### Remarks/Arguments

This Amendment is filed in response to the Office Action dated January 28, 2005. Applicants thank Examiner Peng for the thorough examination of Applicants' invention.

**Amendments of the Drawings**

**FIG. 1A**

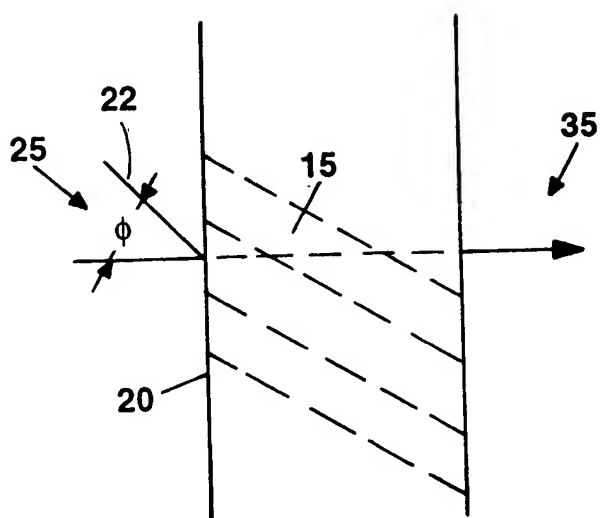
The attached 9 sheets of drawings includes changes to Figs. 1A, 1C, 1D, 4A, 4B, 7, 8, 11 and 12. These 6 sheets, replace the original 6 sheets. It is noted that sheet 2 is not included because there are no amendments on this sheet. In Figures 1A, 1C and 1D, lead lines have been added for clarity; in Figure 1D, the input beam labeled 47 has been relabeled to the correct number 42 (as referred to and described in the specification), and a "Prior Art" label has been added. In figure 4A and 4B, previously omitted labels (referred to and described in the specification) 303 and 360 have been added. In Figure 7, previously omitted label (referred to and described in the specification) 440 has been added, as requested by the Examiner. In Figure 8, previously omitted labels (referred to and described in the specification) 660, 670 and 680 have been added as requested by the examiner, label 615, which is not referred to in the specification, is deleted and labels 611, 612, 613, 614 have been moved in order to render the elements indicated consistent with the specification. In Figure 11, previously omitted label (referred to and described in the specification) 800 (referred to and described in the specification) has been added. In previously submitted Figure 12, the image was shifted from copying; this has been corrected. No new matter is added due to the above amendments; support for any new elements in the drawings can be found in the specification drawing descriptions.
